DR-ALT-33

Table DR-ALT-37-1 Palen Solar Power Project: Environmental Comparison of Alternative Sites

Figure DR-ALT-47-1 PSPP Alternative Reconfigured by Applicant

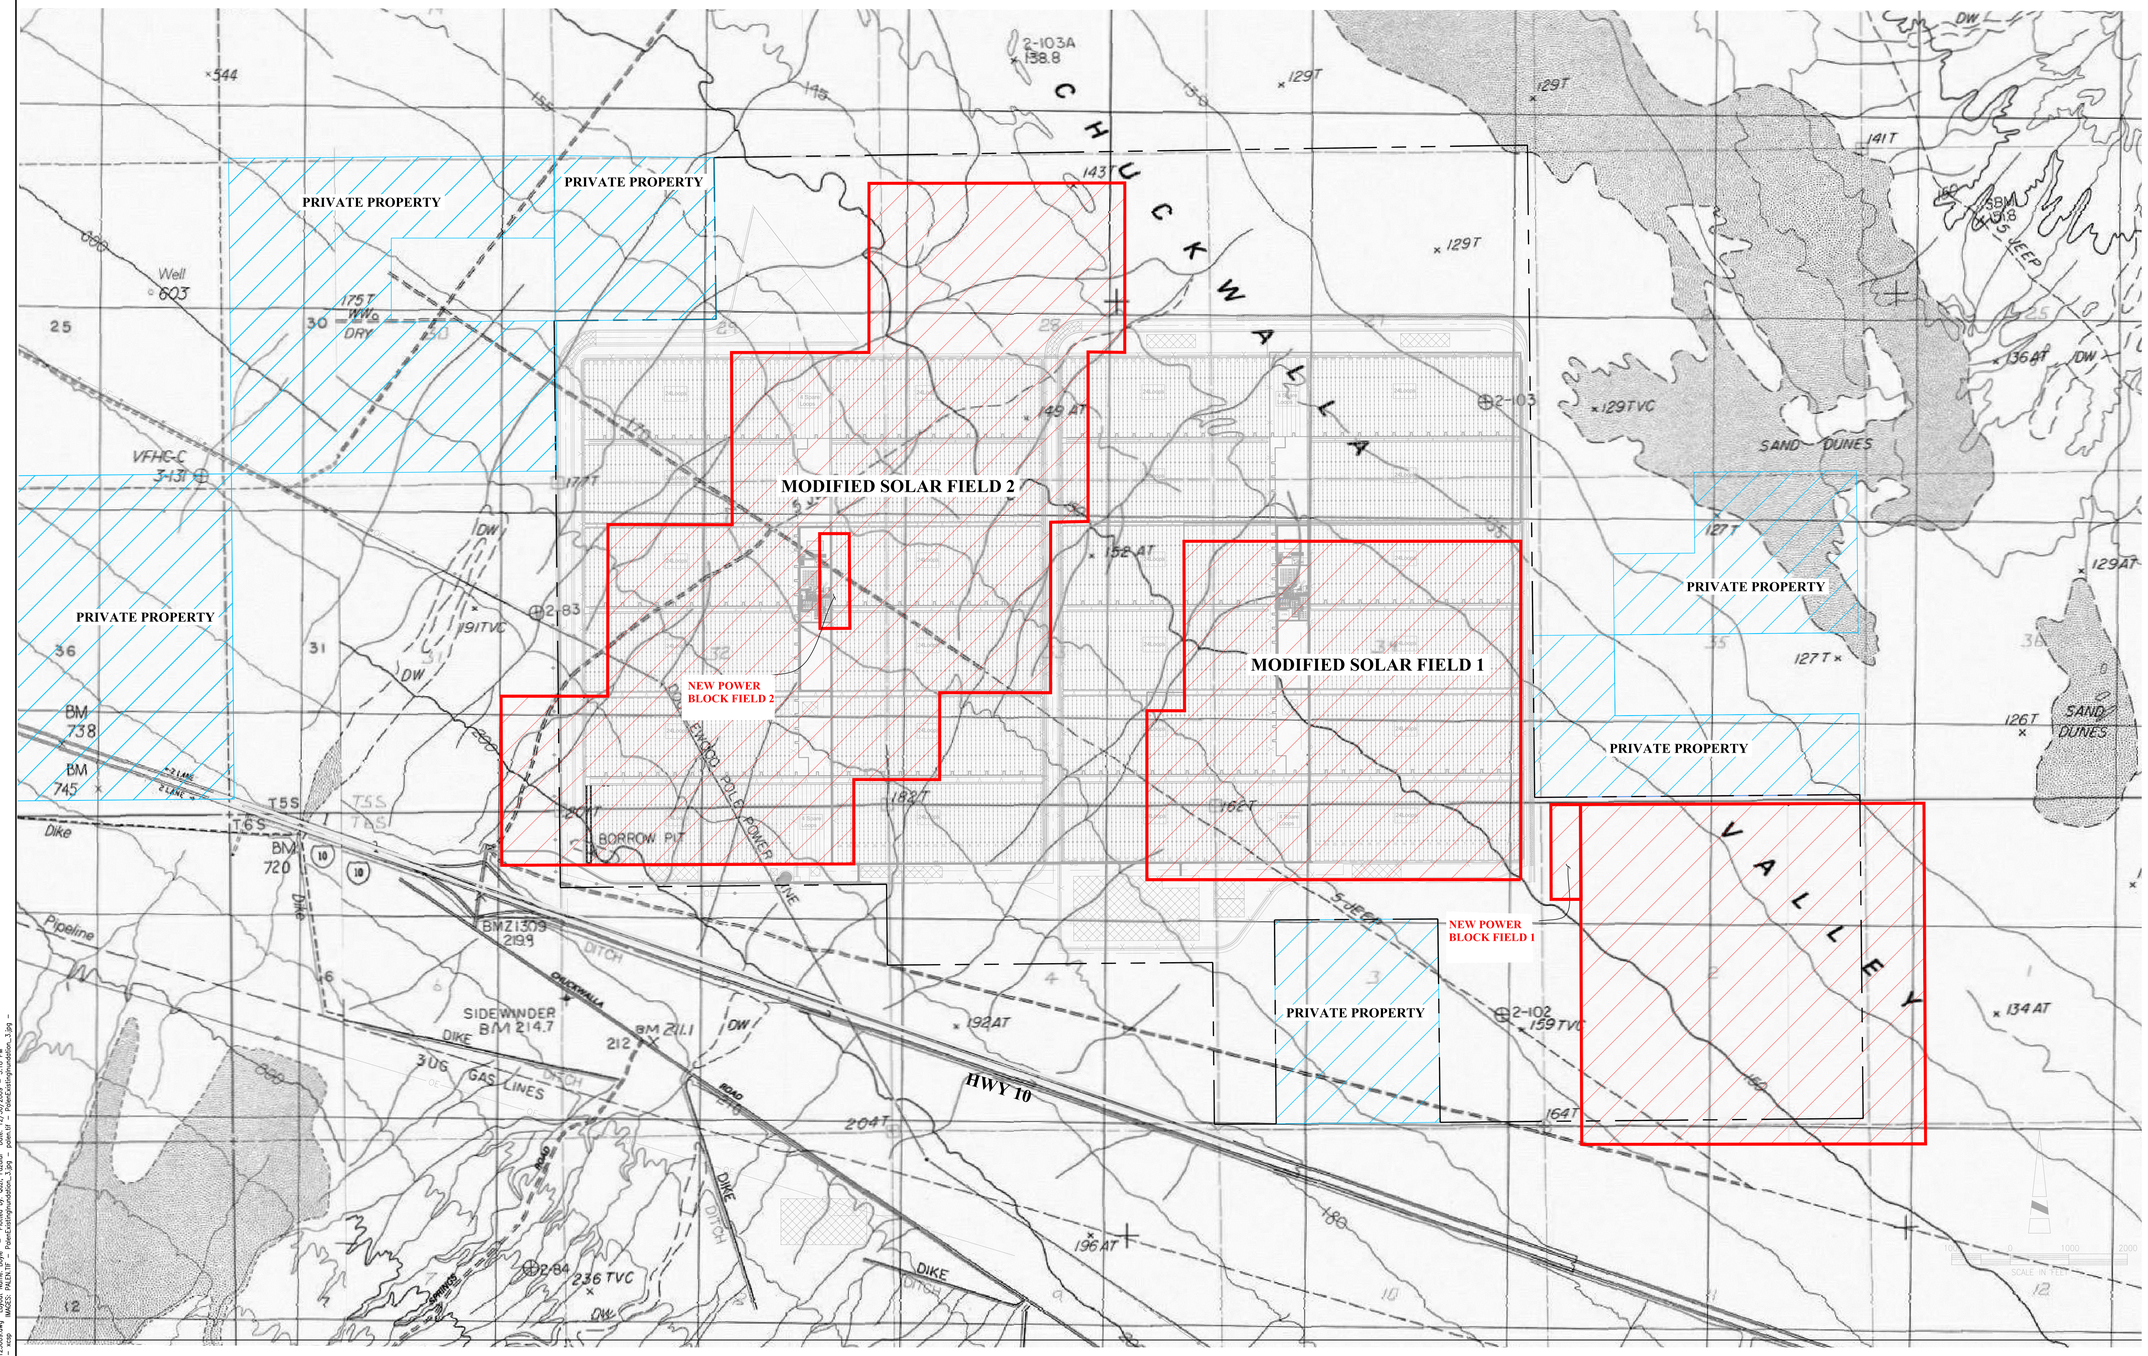
> Please see Alternatives Data Request – Figure 2, which illustrates areas within the project boundaries that are occupied by the most sensitive biological resources – desert washes (shown in green) and Mojave Fringe Toed Lizard habitat (shown in yellow crosshatch). The areas outlined in blue dashes, and red or white lines identify potential

revised configurations that would reduce these effects. In addition, the yellow line illustrates the approximate boundary of the Chuckwalla DWMA. In order for the Energy Commission and BLM to evaluate a potential alternative that avoids effects on these sensitive areas without reducing generation output, surveys must be completed within the portions of these areas that are outside of the current project footprint. Please complete biological and cultural resources surveys (as defined in Title 20, Section 1704, and Division 2, Chapter 5, Appendix B of the CCR for the 12 month process) for the areas outlined in red and not included in the DWMA. Alternatively, complete biological and cultural resources surveys for other areas within the project ROW application boundaries (but outside of the current project footprint) that minimize effects on biological resources to the same degree as the areas identified on Figure 2.

Based on the request in DR-ALT-47 to establish a revised configuration that would reduce effects on the most sensitive biological resources, the Applicant has conducted additional siting analysis. As stated above, the outlined red area is not feasible. In Figure 2, it appears that the CEC Staff uses criteria in establishing a revised configuration that allow the Project facilities outside of the BLM ROW application area. In the additional siting analysis, the Applicant used this flexibility as well as economic and engineering criteria such as described in the response to DR ALT-45, and environmental impact criteria

based on aerial photos and previous Project surveys (e.g., buffer zones surrounding the Project disturbance area), to produce a revised configuration (see Figure DR-ALT-47).

This additional siting analysis has produced a revised configuration (see Figure DR-ALT-47). The newly developed revised configuration would provide less economic output but would preserve the Project's engineering viability and minimize adverse impacts to the most sensitive biological resources. This revised configuration would move the eastern unit onto BLM land within the current ROW application, at the cost of reducing power output. The western solar field, meanwhile, would be revised such that a number of its collectors would be moved north of the existing BLM ROW boundary. As stated in DR-ALT-46, in June 2009, the Applicant relinquished this northern area from their ROW application to minimize the Project's impact on biological and cultural resources (specifically, the ancient Palen Dry Lake shore, sand dunes, and playa). Based on the CEC's criteria stated above and the desire to create a reconfigured alternative outside of the primary wash and northeastern portion of the ROW, the Applicant proposes that Figure DR-ALT-47 be used as the Applicant's reconfigured alternative in lieu of Staff's Figure 2.
